Access Compliance Report

Public Rights-of-Way

(Curb Ramps)

Intersection ID: 11691	Main Street: E_18TH_ST	Cross Street: N_MCDOWELL_ST	Location: S
ADA ID: 5F19033B3B73	Ramp Type: Perp	Initial Pass/Fail: Fail	Overall Compliance: No
Severity Score: 85			
Codes/Mitigation Info/Possible Solution		Field Measurements/Component Compliance

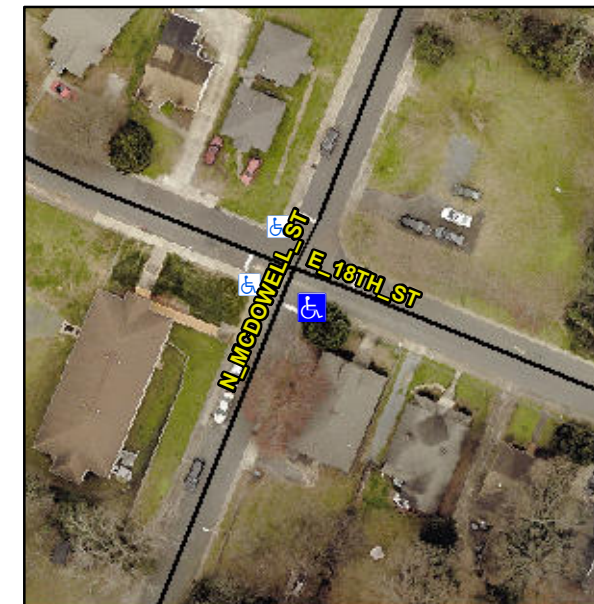
R304.5.1, R304.2.2, R304.5.3

Compliance	Description	Data	Compliance	Description	Data
N/A	Ramp Length (in)	56.5	No	Ramp Slope (%)	15.4
No	Ramp Width (in)	24.0	No	Ramp XSlope (%)	7.1
N/A	Flare Type LT	N/A	N/A	Flare Type RT	N/A
N/A	Flare Slope LT (%)	N/A	N/A	Flare Slope RT (%)	N/A
N/A	Flare Traversable LT?	N/A	N/A	Flare Traversable RT?	N/A
N/A	Landing Length (in)	N/A	N/A	DWS Provided?	N/A
N/A	Landing Width (in)	N/A	N/A	DWS Contrast?	N/A
N/A	Landing Slope (%)	N/A	N/A	DWS Length (in)	N/A
N/A	Landing X Slope (%)	N/A	N/A	DWS Full Width?	N/A
N/A	Landing Curb? (Y/N)	N/A	N/A	DWS Offset (in)	N/A
N/A	Shared Landing?	N/A			
N/A	Gutter Ponding?	N/A	N/A	Gutter Slope (%)	N/A
N/A	Gutter Lip Ht (in)	N/A	N/A	Gutter X Slope (%)	N/A
N/A	Painted X Walk1?	No	N/A	Painted X Walk2?	N/A
	X Walk 1 Direction	To NW		X Walk 2 Direction	N/A
N/A	X Walk 1 Width (in)	N/A	N/A	X Walk 2 Width (in)	N/A
	X Walk 1 Slope (%)	5.8		X Walk 2 Slope (%)	N/A
	X Walk 1 X Slope (%)	0.3		X Walk 2 X Slope (%)	N/A

Remove & Replace Entire Ramp.
